DEPARTMENT OF PUBLIC WORKS

VOL. 1: STANDARD DRAWINGS

Addendum No. 10
Published: January 2025

ADDENDUM No. 10
TO THE
CITY OF FRESNO
PUBLIC WORKS STANDARD DRAWINGS AND SPECIFICATIONS
ADOPTED MARCH 4, 1970, BY RESOLUTION NO. 70-36

SEWER PIPES W/DIA. UP TO AND INCLUDING 27" WITH
PRECAST SECTIONS AND CAST IRON FRAME AND COVER

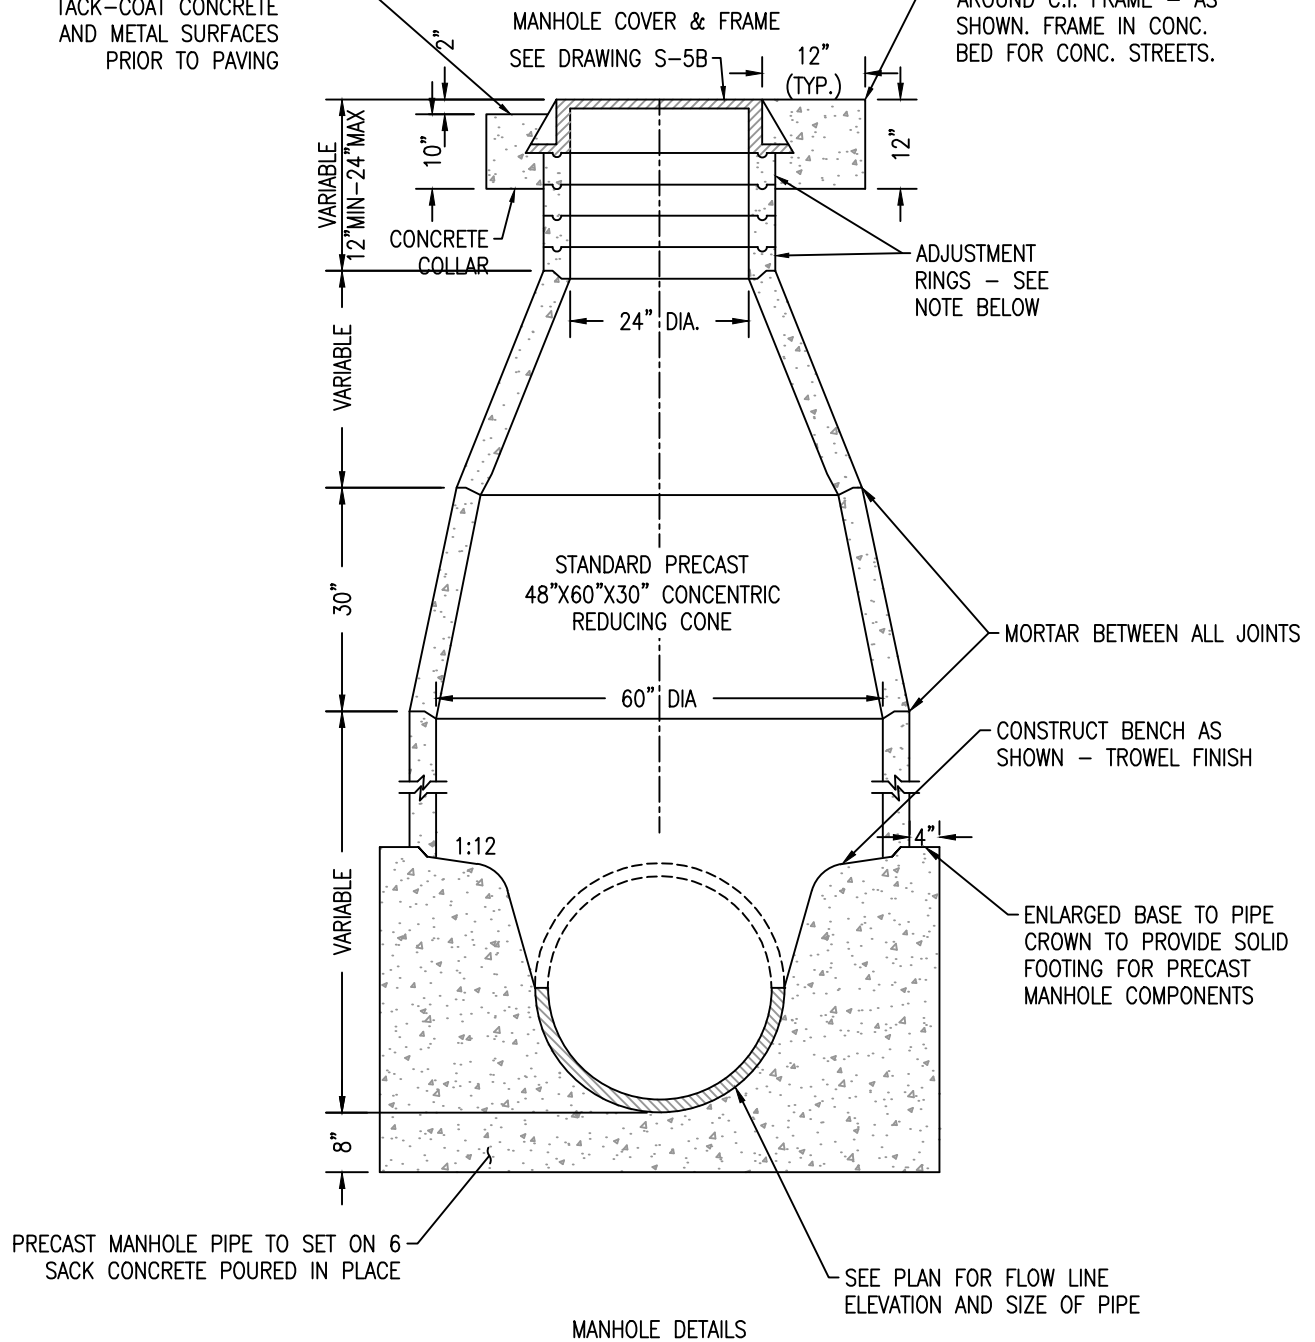
S-3	<p>1. Callout: "SEE DRAWING S-5B OR *S-5B" Revised to read: "SEE DRAWING S-5A OR *S-5B"</p> <p>2. *NOTE: "S-5B FOR 27" DIAMETER PIPES" Revised to read: "S-5B FOR 27" OR LARGER DIAMETER PIPES"</p> <p>3. General Note 1, "PRECAST RISER SECTIONS, ADJUSTMENT RINGS AND TAPERED SECTIONS SHALL BE IN ACCORDANCE WITH ASTM C-478. ELLIPTICAL SINGLE LINE REINFORCEMENT WILL NOT BE PERMITTED" Revised to read: "PRECAST RISER SECTIONS, ADJUSTMENT RINGS & TAPERED SECTIONS SHALL BE CLASS 2 R.C.P. IN ACCORDANCE WITH ASTM C-478. ELLIPTICAL SINGLE LINE REINFORCEMENT WILL NOT BE PERMITTED.</p> <p>4. General Note 2, "THIS STANDARD DRAWING SHALL BE USED FOR SEWER PIPES WITH DIAMETERS OF UP TO 27'" Revised to read: "THIS STANDARD DRAWING SHALL BE USED FOR SEWER PIPES WITH DIAMETERS OF UP TO AND INCLUDING 27'"</p> <p>5. General Note 4, "MANHOLE SHALL BE LINED WITH T-LOCK OR COATED WITH ONE OF THE FOLLOWING: RAVEN 400 OR RAVEN 405, PRODUCTS OF RLS SOLUTIONS; NEOPOXY 5300 SERIES, PRODUCTS OF NEOPOXY INTERNATIONAL; OR QUADEX STRUCTURE GUARD, A PRODUCT OF QUADEX. APPROVED PRODUCTS SHALL BE APPLIED PER MANUFACTURER'S SPECS. NO SUBSTITUTIONS ARE ACCEPTABLE." Revised to read: "MANHOLE SHALL BE LINED WITH T-LOCK OR COATED WITH ONE OF THE FOLLOWING: RAVEN 400, 405 OR 405FS, PRODUCTS OF RLS SOLUTIONS; NEOPOXY 5304 OR 5305, PRODUCTS OF NEOPOXY INTERNATIONAL; OR QUADEX</p>

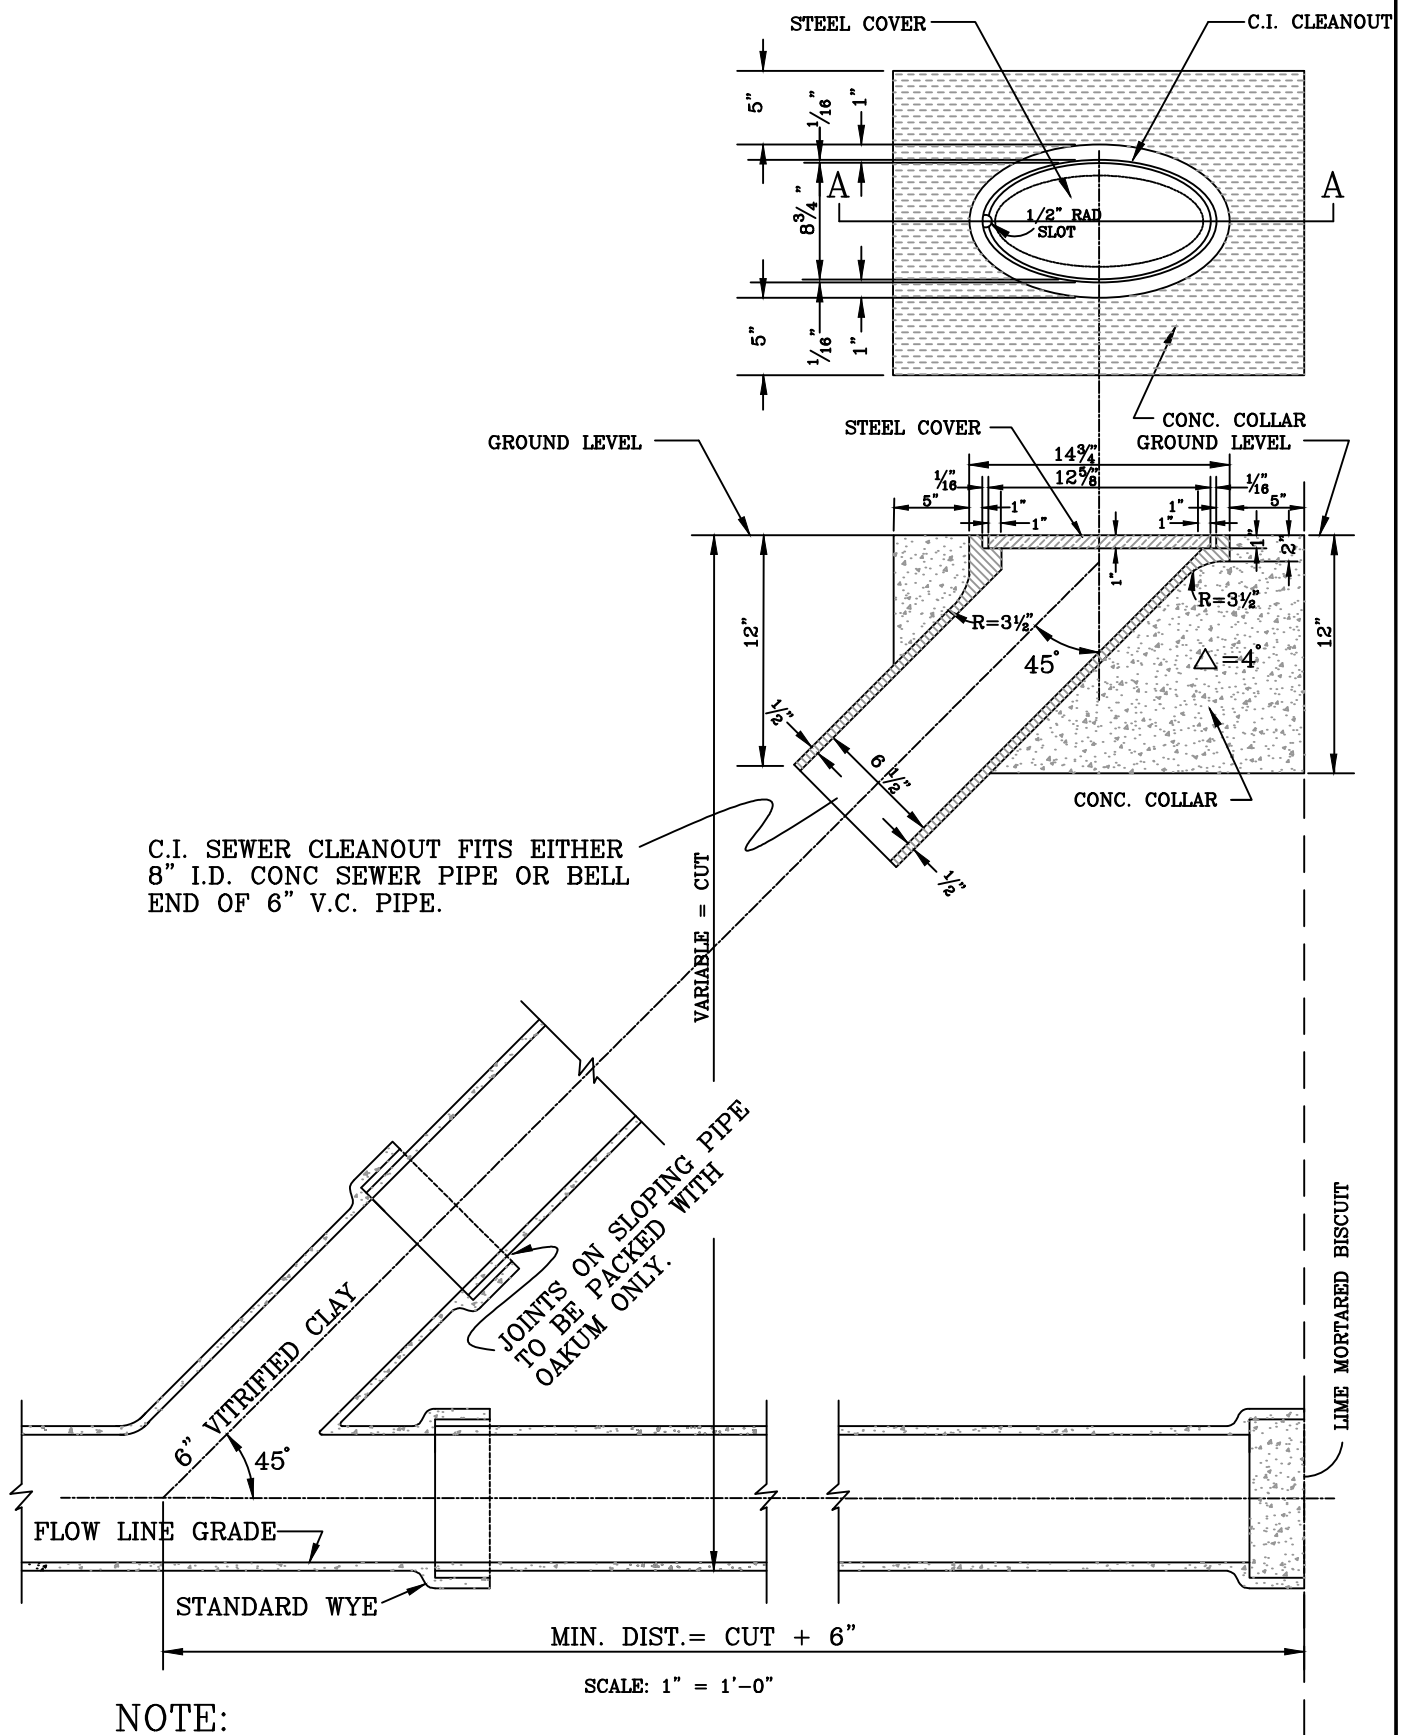
- S-5B** Added Note 8 regarding placement of manhole cover opening.
- S-7** Replace "S-7" with "S-7A and S-7B"
- S-8** Changed house branch Tee Fitting material to SDR35 to match uniform plumbing code
Changed compression fitting to Gasket PVC Hub
Added "Total gap not to exceed ½" note to ensure proper connection is made.
- S-9** Clarified Note 4 regarding maximum extension of the saddle into the sewer main.
- S-10** Replace "Ref. Std. Dwg. P-40" with "Ref. Std. Dwg. P-48"
- S-11A** Added note to "Min. Model Height" to address heights less than minimum.
- S-12** Correction to Note 2.

CITY OF FRESNO
RW-7

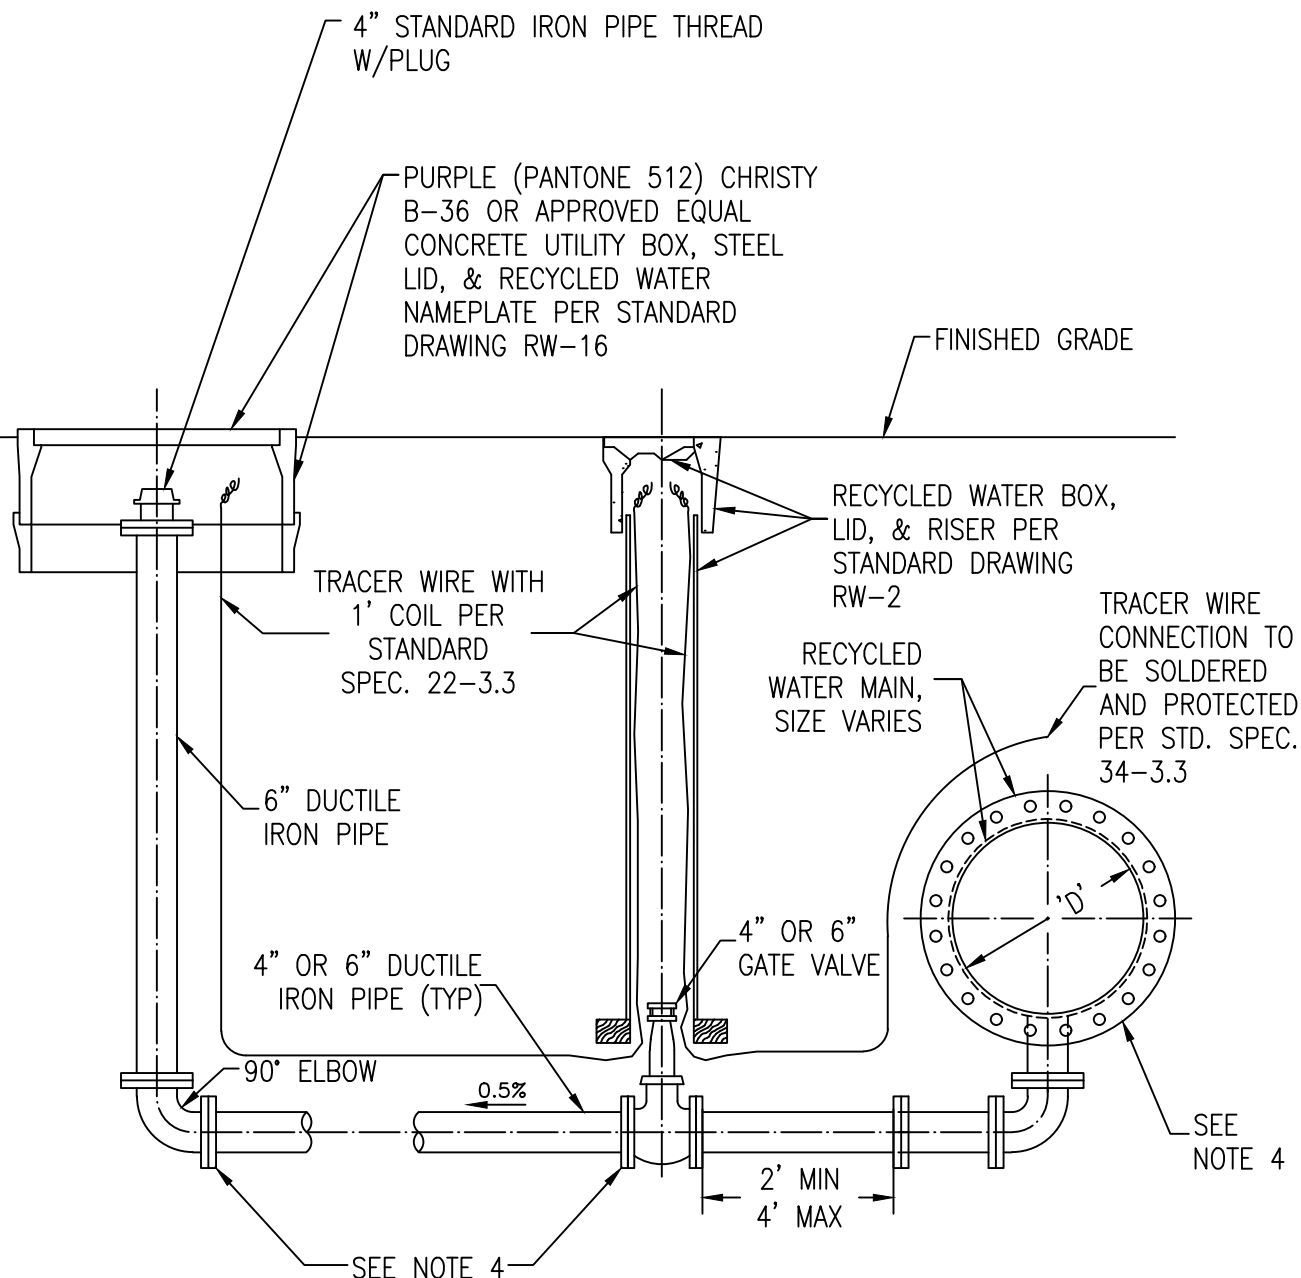
RW-7	<ol style="list-style-type: none"> Callout: "PURPLE (PANTONE 512) CHRISTY METER BOX WITH LID (17" X 30") AND MARKED WITH THE WORDS "RECYCLED WATER"" Revised to read: "PURPLE (PANTONE 512) CHRISTY B-36 OR APPROVED EQUAL CONCRETE BOX, STEEL LID AND RECYCLED WATER NAME PLATE PER STANDARD DRAWING RW-16" Callout: "2" x REQUIRED LENGTH GALVANIZED STEEL PIPE TYPE "K" RIGID OR SOFT, CONTINUOUSLY WRAPPED WITH APPROVED PURPLE RECYCLED WATER MARKING TAPE" Revised to read: "2" x REQUIRED LENGTH GALVANIZED STEEL PIPE, CONTINUOUSLY WRAPPED WITH APPROVED PURPLE RECYCLED WATER MARKING TAPE" Callout: "TRACER WIRE WITH 1' COIL PER STANDARD SPEC. 22-3.3" Revised to read: "TRACER WIRE WITH 1' COIL PER STANDARD SPEC. 34-3.3" Note 3: "RESTRAIN ALL JOINTS PER SITY STANDARD SPECIFICATIONS SECTION 21-15.5" Revised to read, "RESTRAIN ALL JOINTS PER SITY STANDARD SPECIFICATIONS SECTION 33-14.5"
RW-8	<ol style="list-style-type: none"> Drawing split and renamed, "RW-8A" and "RW-8B". Technical changes shown for RW-8A, below, apply to both.

CITY OF FRESNO
RW-8A

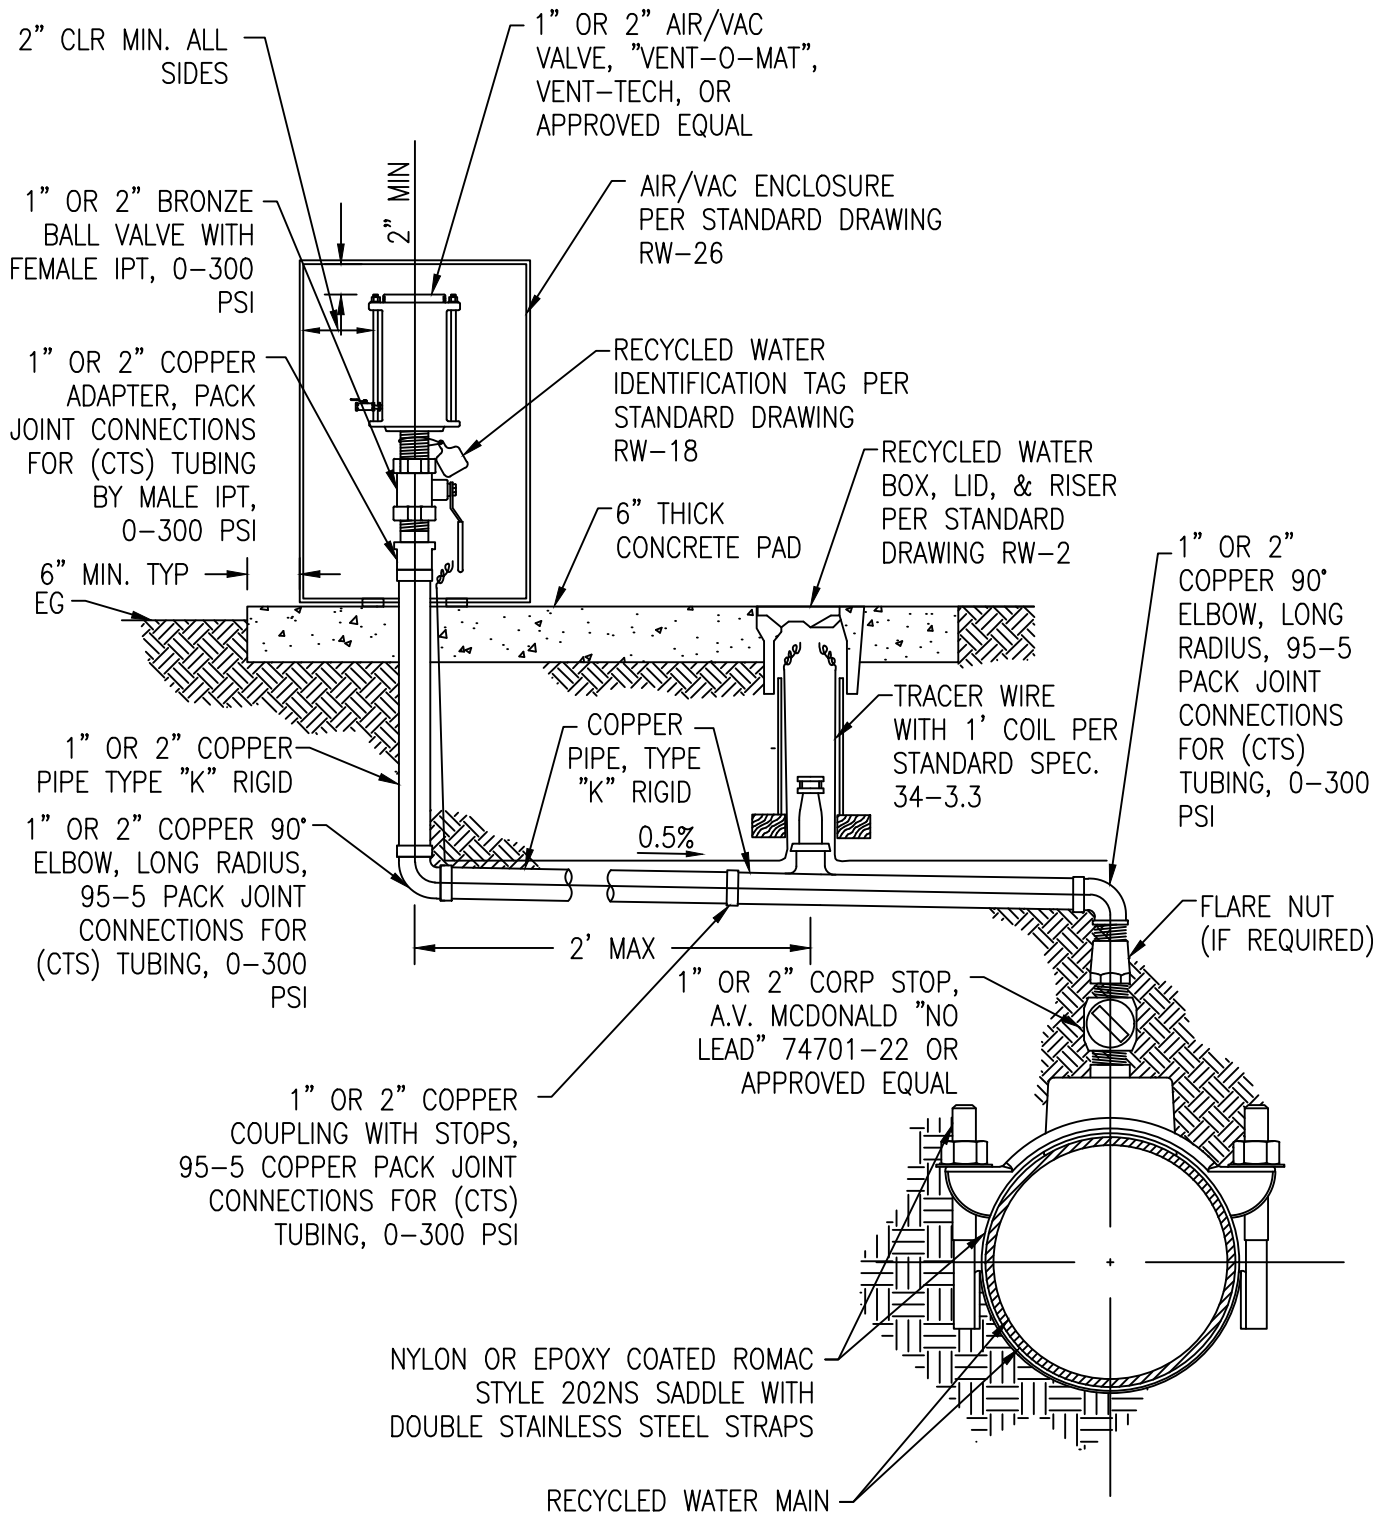
RW-8A	<ol style="list-style-type: none"> Drawing title, "RECYCLED WATER BLOW-OFF ASSEMBLY" Revised to read: "RECYCLED WATER BLOW-OFF ASSEMBLY (PVC OR DUCTILE IRON MAIN)" Callout, "2-1/2" STANDARD MALE FIRE HOSE THREADED CONNECTION WITH CAP & RECYCLED WATER IDENTIFICATION TAG PER STANDARD DRAWING RW-18" Revised to read: "4" STANDARD IRON PIPE THREAD W/PLUG". Drawing Revised: Blow-off connection to main changed from 45° ELL to 90° ELL at bottom of pipe. Note 4: "RESTRAIN ALL JOINTS PER SITY STANDARD SPECIFICATIONS SECTION 21-15.5" Revised to read, "RESTRAIN ALL JOINTS PER SITY STANDARD SPECIFICATIONS SECTION 33-14.5" Callout: "TRACER WIRE CONNECTION TO BE SOLDERED PER STD. SPEC. 34-3.3" Revised to read, "TRACER WIRE CONNECTION TO BE PROTECTED AND SOLDERED PER STD. SPEC. 34-3.3"
